Product Advisory (PA)

Subject: Addition of full tray packaging for MCU products (RX/RA/Synergy)

SAG-B-24-0002
PC-MCU-A030A/E

Example of interior label of full tray packaging

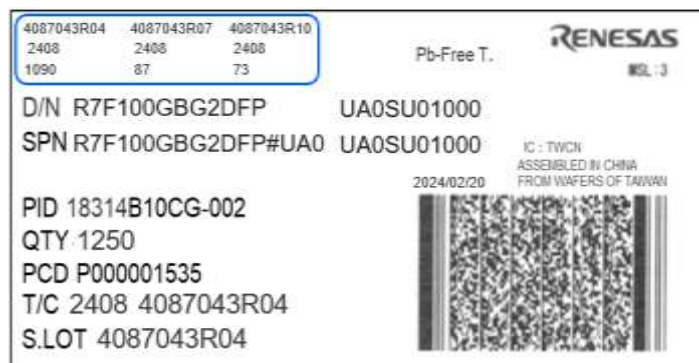
Cases printed in the upper left area of the interior label

Cases not printed in the upper left area of the interior label
